TULARE CITY

ADDENDUM # 1 TO BID DOCUMENT
Installation of Painting at various sites
BID OPENING: Wednesday, March 18, 2020 at 11:00 a.m.

BUILDING "E": FLOOR PLAN

LOS TULES MIDDLE SCHOOL
 801 West Gail Avenue - Tulare, CA 93274

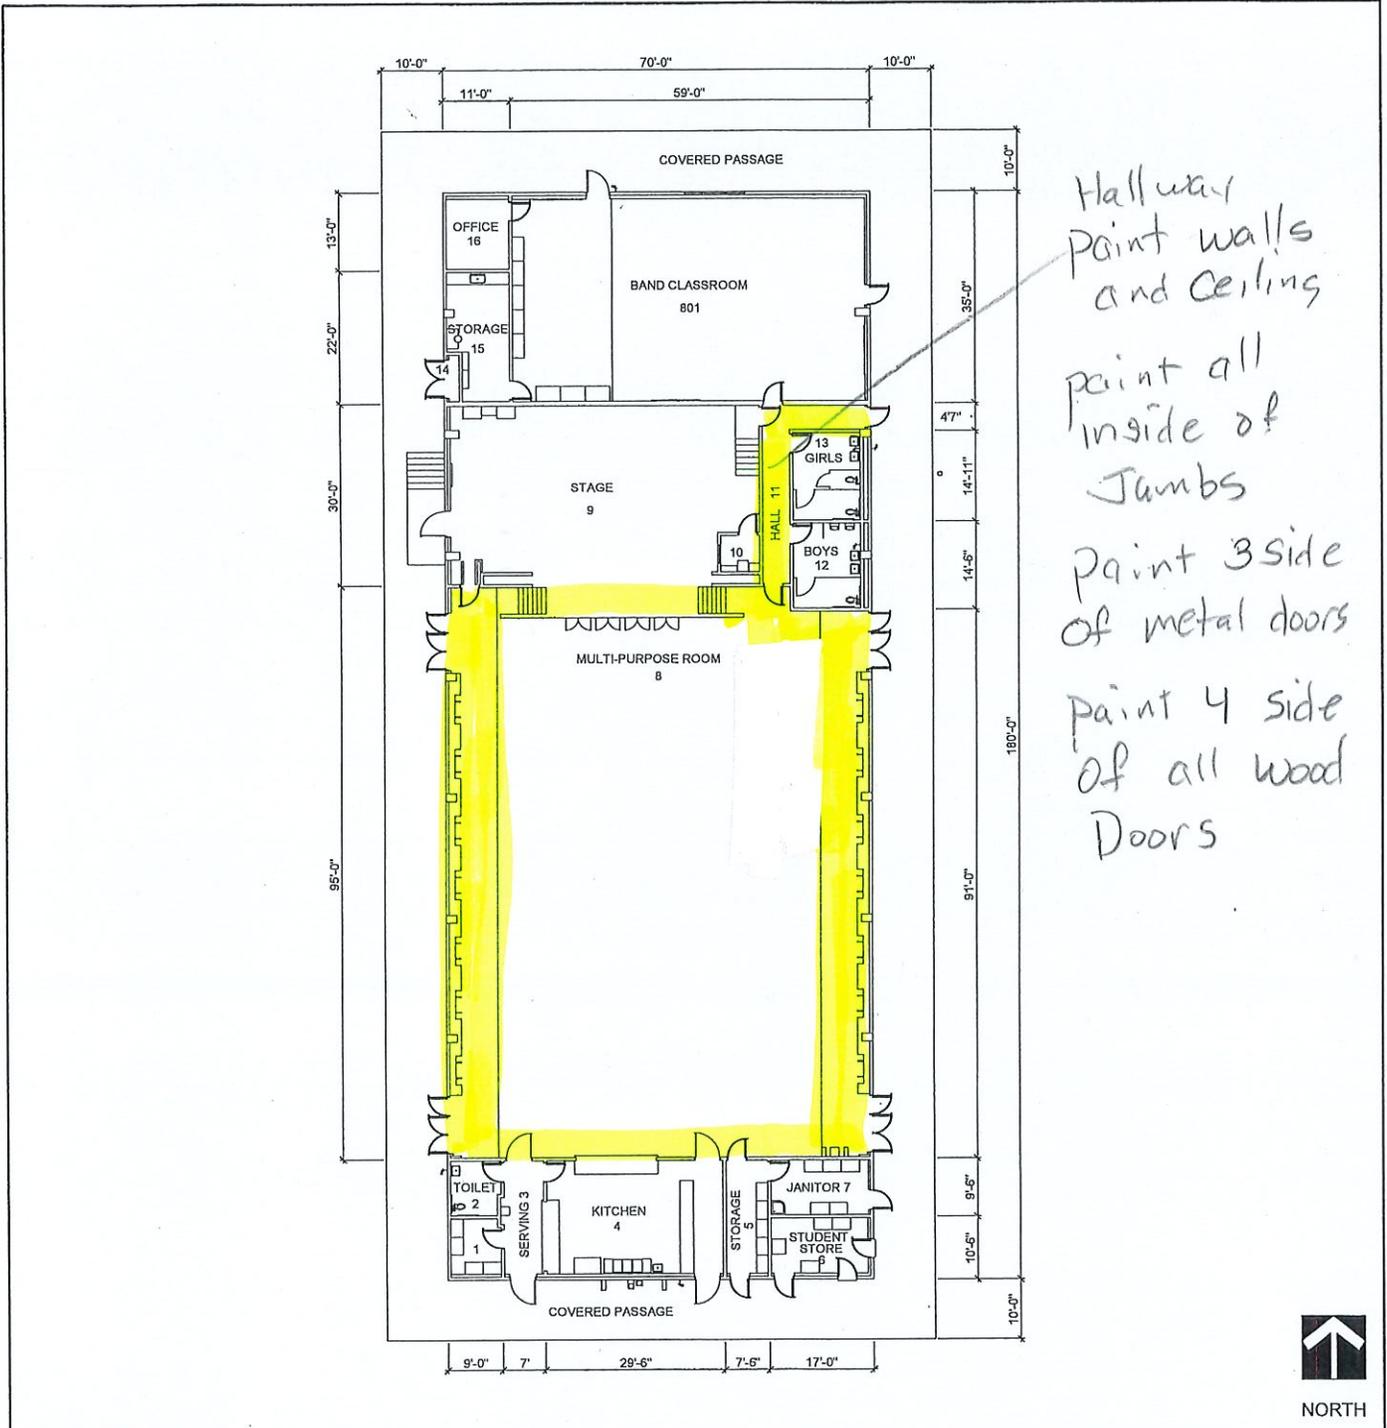
Hallway
 paint walls
 and ceiling

paint all
 inside of
 Jambs

paint 3 side
 of metal doors

paint 4 side
 of all wood
 Doors

1. In all Classrooms & Multi-Purpose Room Contractor must caulk all joints, corners, & at top of T-bar ceiling. Owner will supply the Caulk.
2. Los Tules Middle School – Multi Purpose room Contractor to paint walls, interior doors, inside of jambs, paint 3 sides of metal doors, & paint 4 side of all wood doors. Multi-Purpose room hallway, Contractor to paint walls and ceiling, interior doors, inside of jambs, paint 3 sides of metal doors & 4 sides of all wood doors. See drawing attached.
